**Burdett Solar Project**

**Alberta Utilities Commission**

Decision 27488-D01-2023

Application 27488-A001

Figure 1. Proposed Burdett Solar Project boundary

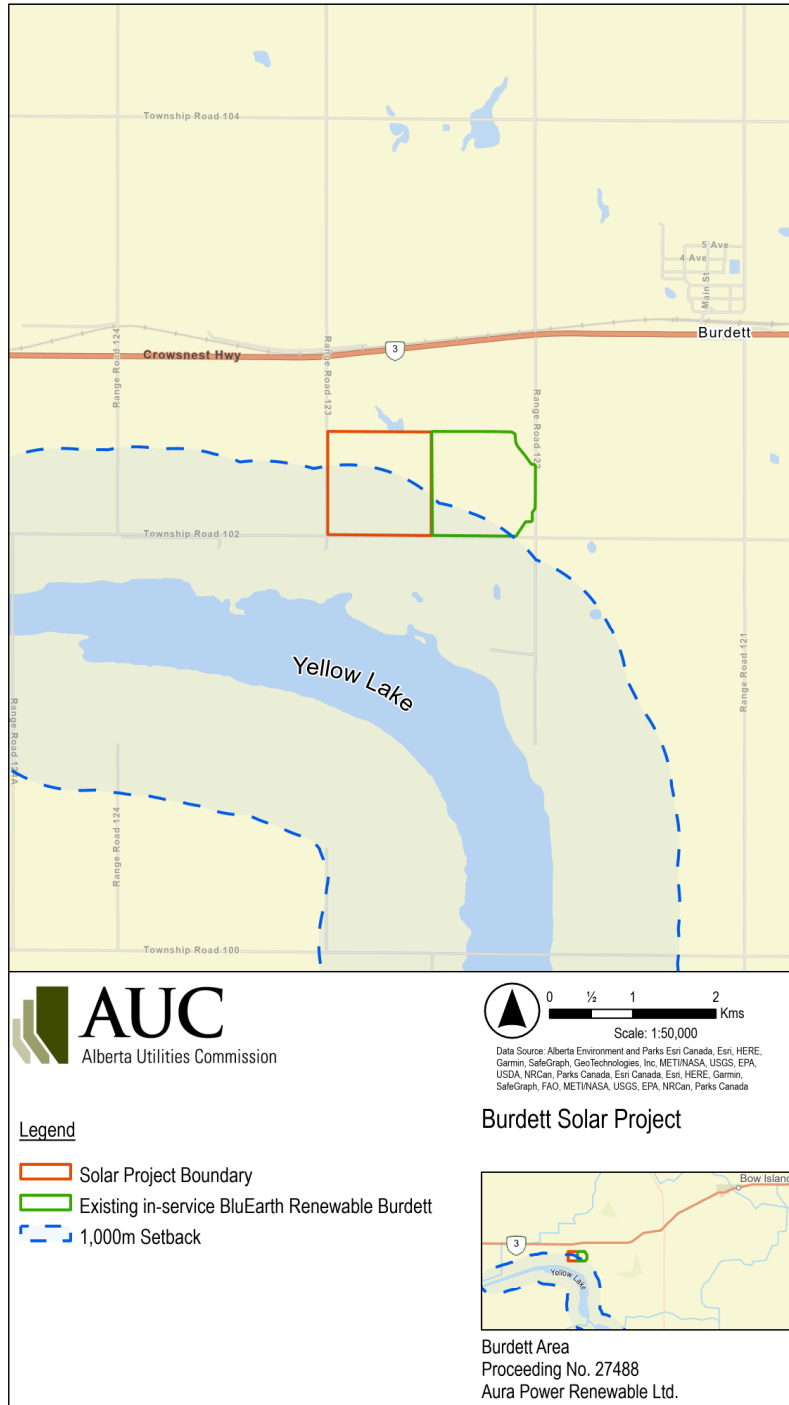
22. The closest project infrastructure is sited approximately 438 metres from Yellow Lake, well within the 1,000-metre boundary outlined by the Directive.<sup>25</sup>

24. The 1,000-metre setback prescribed by the Directive is shown in Figure 1 relative to the proposed project area.

28. Named lakes are known features and the Commission considers it unacceptable to significantly infringe upon the 1,000-metre setback from a named lake. The project layout, as proposed, sites the majority of the infrastructure within 1,000 metres of Yellow Lake. Unlike a situation in which a sensitive wildlife feature is discovered following wildlife surveys (e.g., a nest or amphibian breeding habitat), where the feature could not have been known in the early planning stages, the project as currently sited is not consistent with the known 1,000-metre setback. The infringement of this standard was known as early as 2017 when the Directive was first issued.

46. The Commission finds that approval of the application is not in the public interest. The Commission denies Application 27488-A001 for Aura Power Renewables Ltd. to construct and operate the Burdett Solar Project and to connect the project to the FortisAlberta Inc. distribution system.
